DELHI DEVELOPMENT AUTHORITY
(MASTER PLAN SECTION)

Sub: Corridor Improvement Plan of Road No. 56 from its intersection with
NH-24 (Ghazipur Crossing) to Anand Vihar Metropolitan Terminal Cum-ISBT.

Fig - 1 Key Map

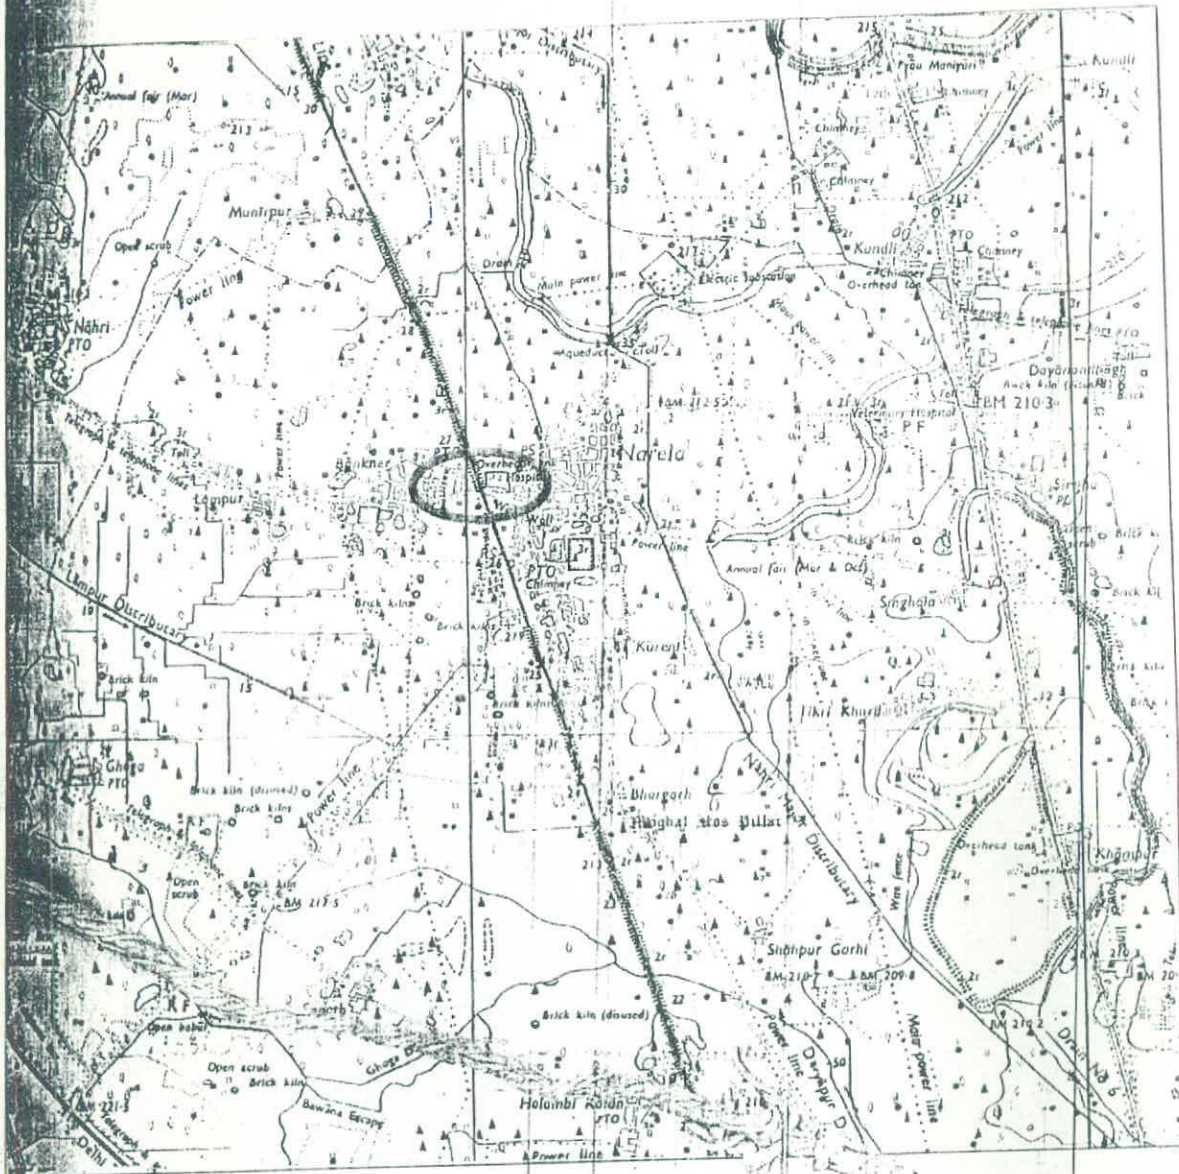
1. The proposal shall be got approved from the northern railway and other statutory bodies as required
2. Ten times the number of trees required to be cut shall be planted after approval of competent authority.
3. R/W of the road has been proposed as 30 mt. And in the immediate phase 24 mt. R/W shall be developed due to existing built up structures

KEY PLAN SHOWING THE STUDY LOCATIONS

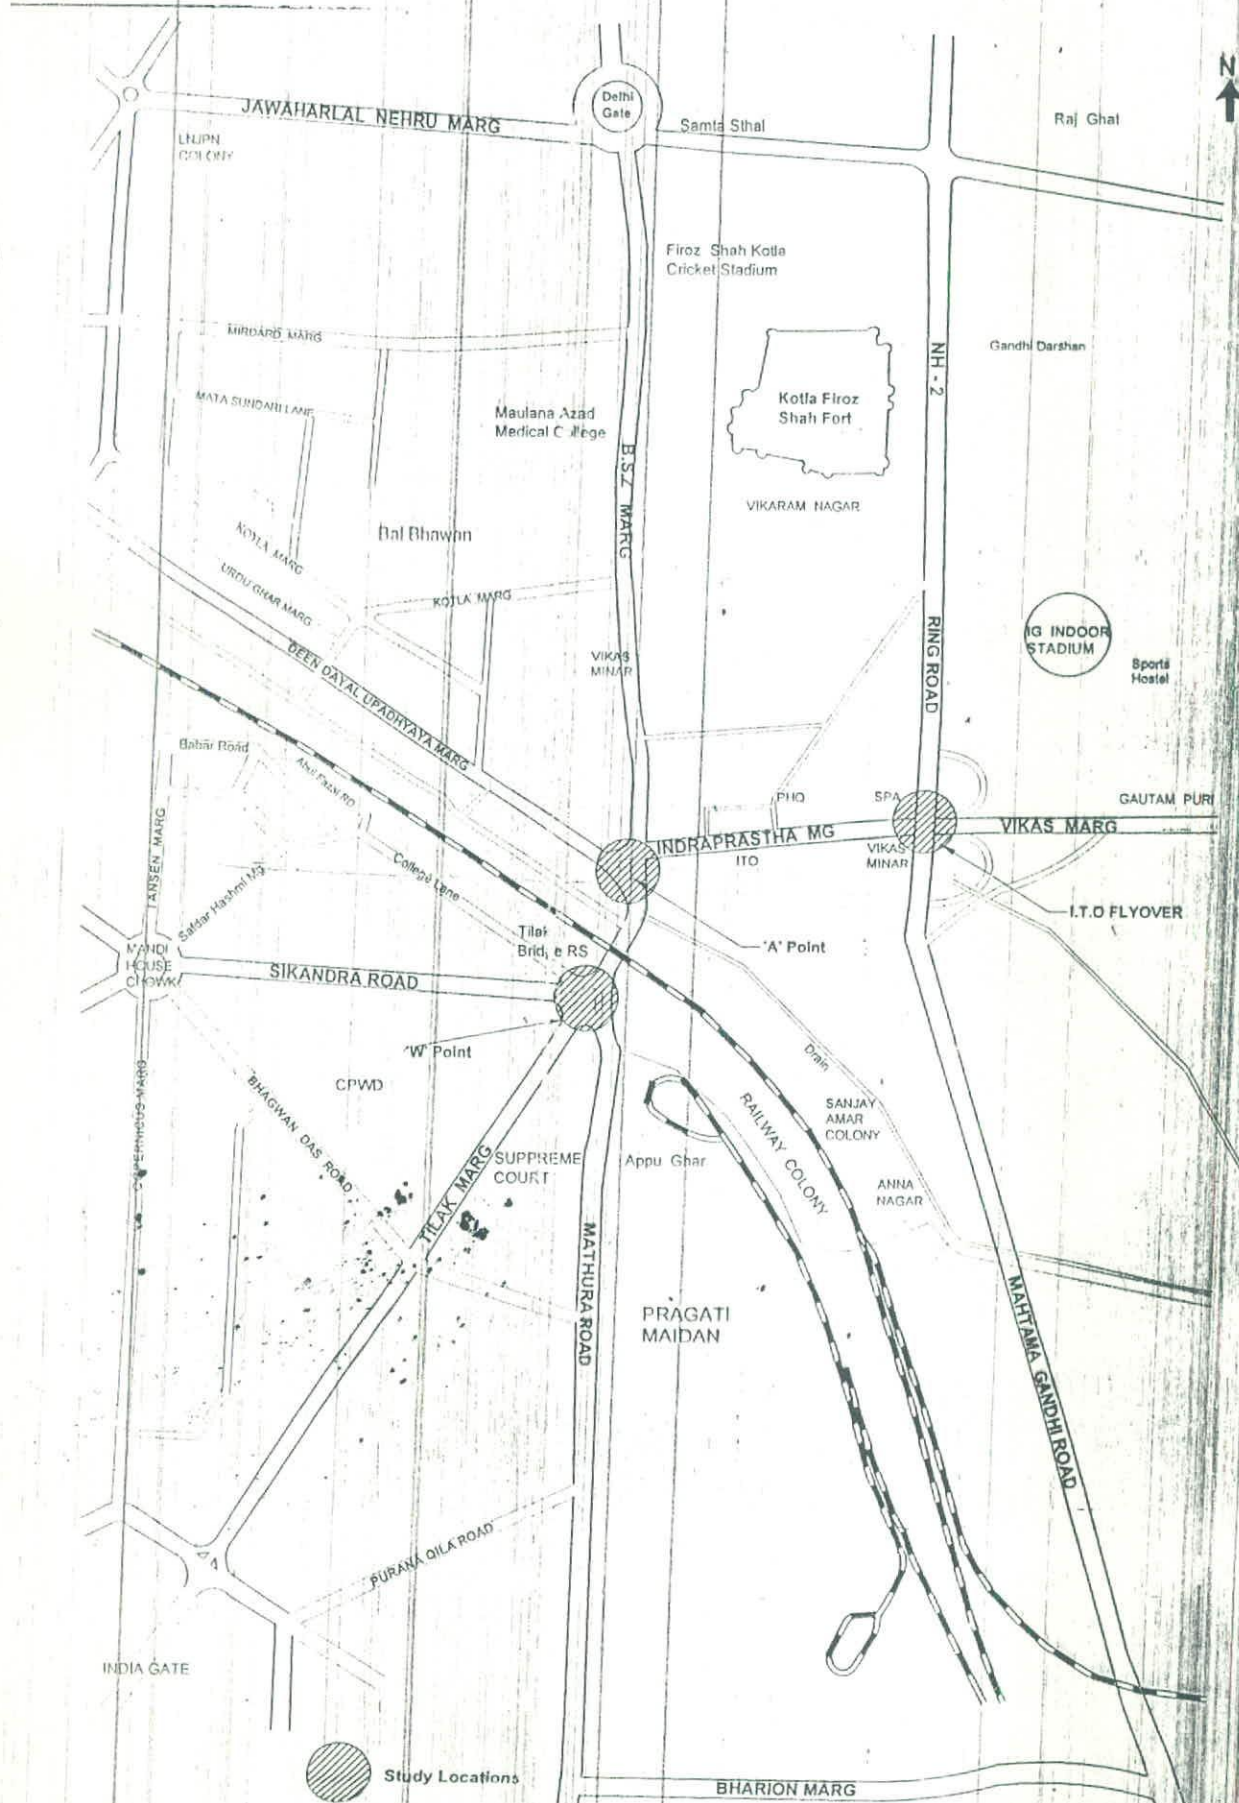
1. The observations of the Sub - Committee regarding integration of 'A' - 'W' point and East - West Corridor has not been done, mentioning that the two corridors will have distinct movement pattern. However, the integration in terms of public transport, circulation, pedestrian, cyclist movement in the entire ITO Complex and linkages with the Metro Stations, Railway Stations and major Bus Stops along BSZ Marg and I.P. Marg needs to be clearly shown in different level on a detailed plan with a model as per the decision of the Sub - Committee.
